From: Ryan, Mary X [Mary.Ryan@nationalgrid.com]
Sent: 21/03/2017 12:18:19
To: Johnson, Stephen [/O=AWGPLC/OU=First Administrative Group/cn=Recipients/cn=Johnson, Stephen]
CC: Dolan, Matthew [/O=AWGPLC/OU=First Administrative Group/cn=Recipients/cn=Dolan, Matthew]
Subject: Grenfell Tower
Attachments: 182 Grenfell tower.
Importance: High

As we discussed on Friday, Pat has visited Grenfell this morning to review the works completed, paying particular attention to the flats where Holland Gas have undertaken Internal Works.

Flat 182

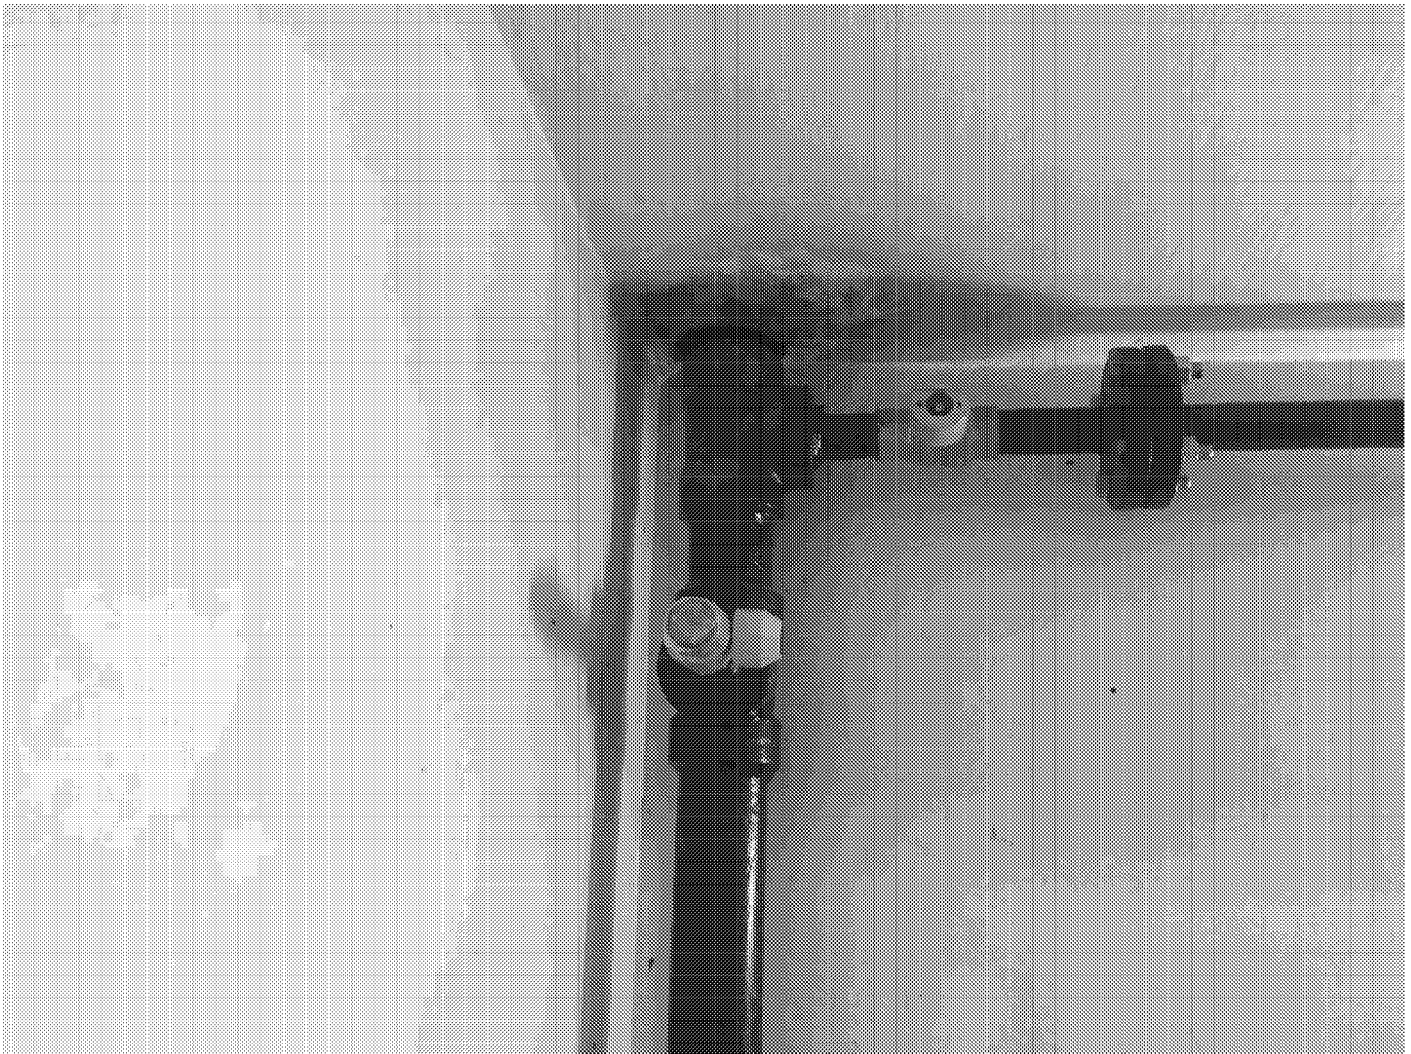
The agreement with the LA was to install the new supply in the fire exit stairwell and box in to meet their evacuation requirements. This has not been completed, although there are ventilation holes throughout the stairwell, which if a fire incident did occur would create a more unsafe situation.

Flat 182

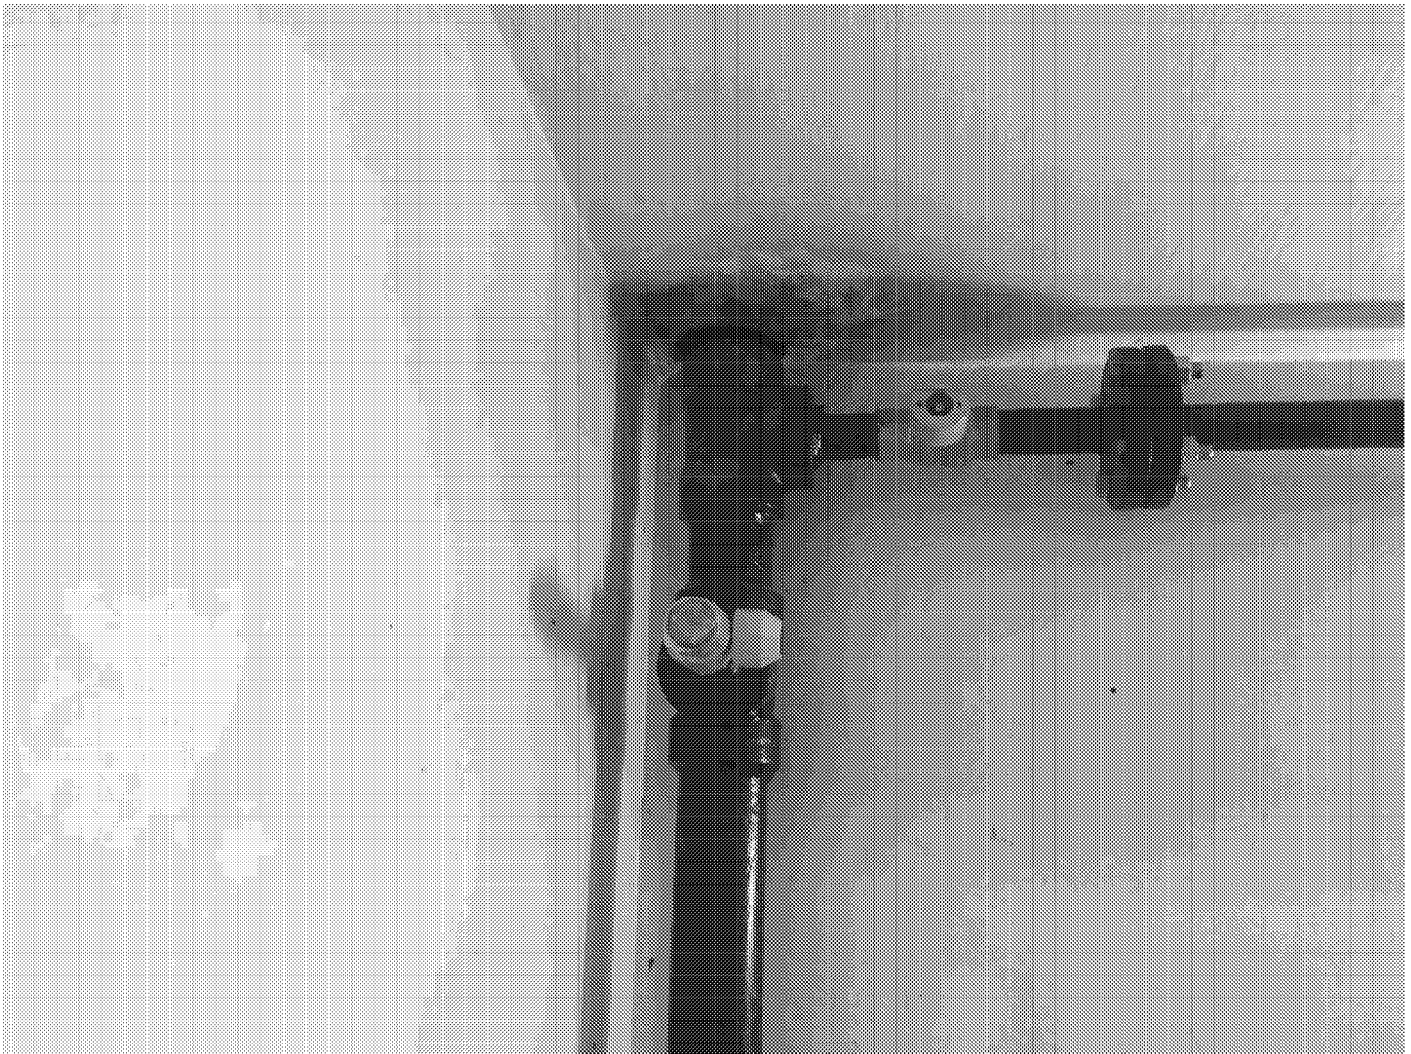
The agreement with the LA was to install the new supply in the fire exit stairwell and box in to meet their evacuation requirements. This has not been completed, although there are ventilation holes throughout the stairwell, which if a fire incident did occur would create a more unsafe situation.
